To
Subject Kalamazoo Meeting Materials

OU1 Design Issues

WCS Issues

SITE PREPARATION AND DRAINAGE PLAN

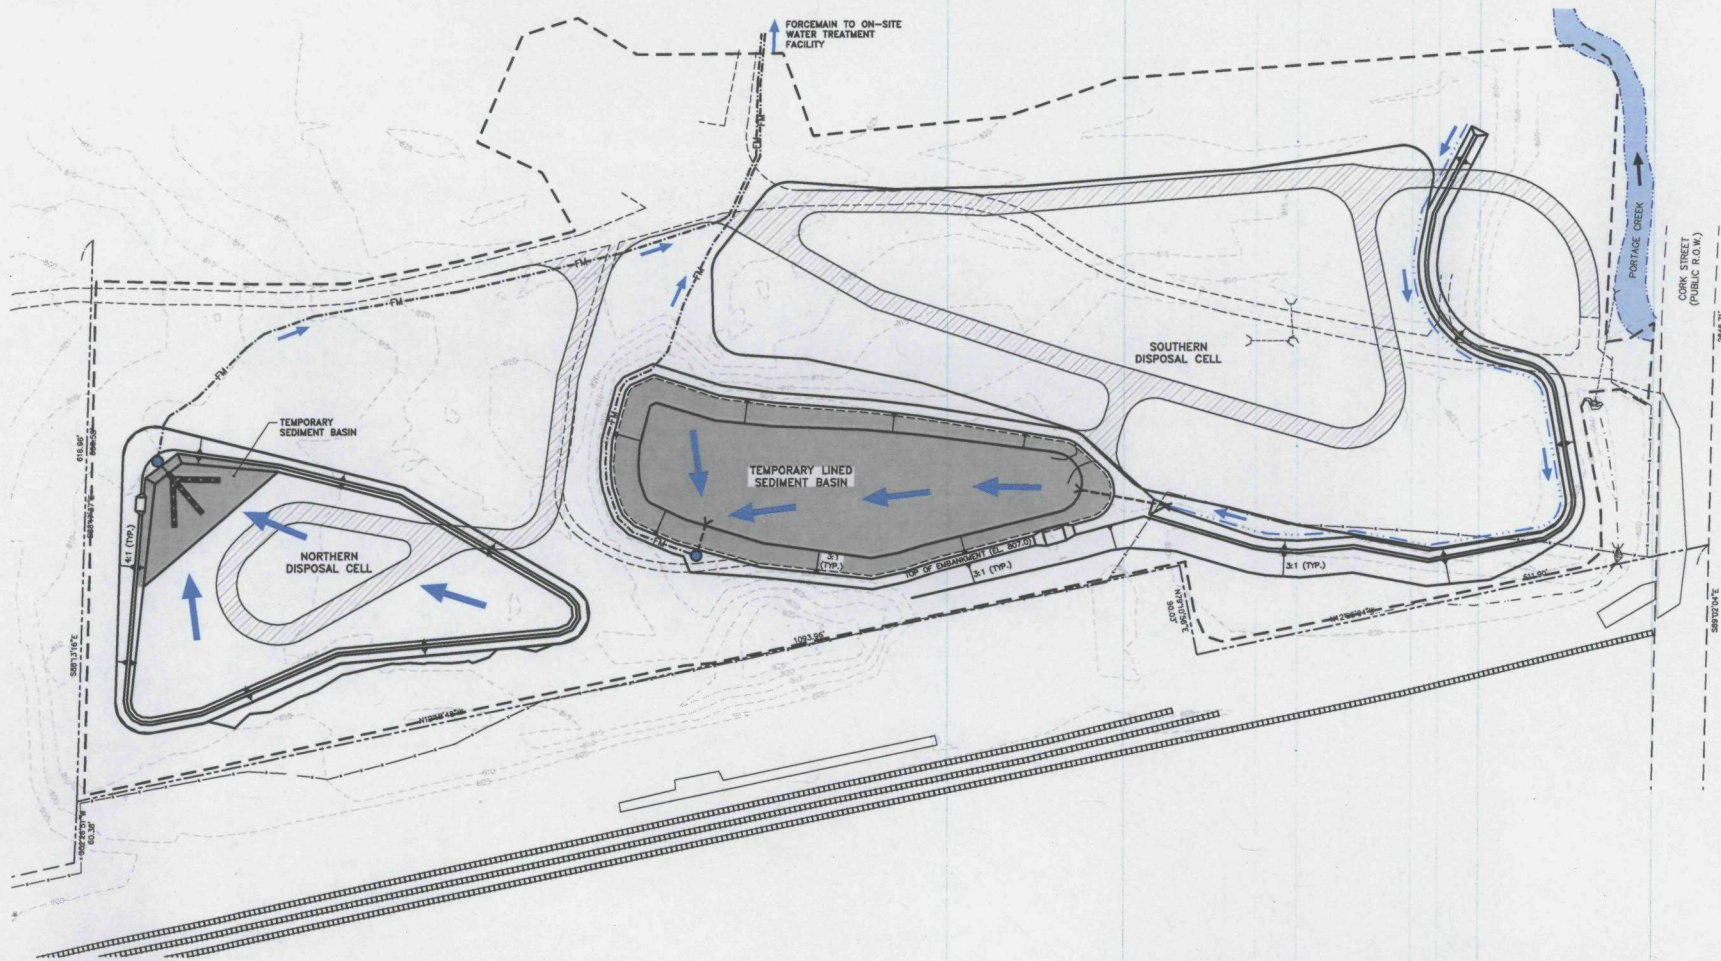
- Based on current design, it appears non-contact storm water is not achievable (based on the permeable vegetated cover material selected and the outfall points look to be over existing residual areas). Easiest fix is to treat all water accumulated in the basin.

- Regardless of contact or non-contact storm water scenario, liner system for sediment basin must be upgraded to composite, double-lined design (synthetic top liner and composite bottom liner) with leachate collection and removal system between the liners and above the top liner (rule 308 of part 115 rules references rule 423, Rule 423 says among other things that the LF will need to achieve technical standards of 40 CFR, 264.221). Additional detail include (bottom slope to minimize head on liner, sump design, pump design)

- If still designing to allow non-contact scenario, current gravity drain seems somewhat impossible at elevations identified. Again, liner system must be upgraded to composite, double-lined design. Outfalls will have to be repaired so storm water is not traveling over where historic residuals already exist.
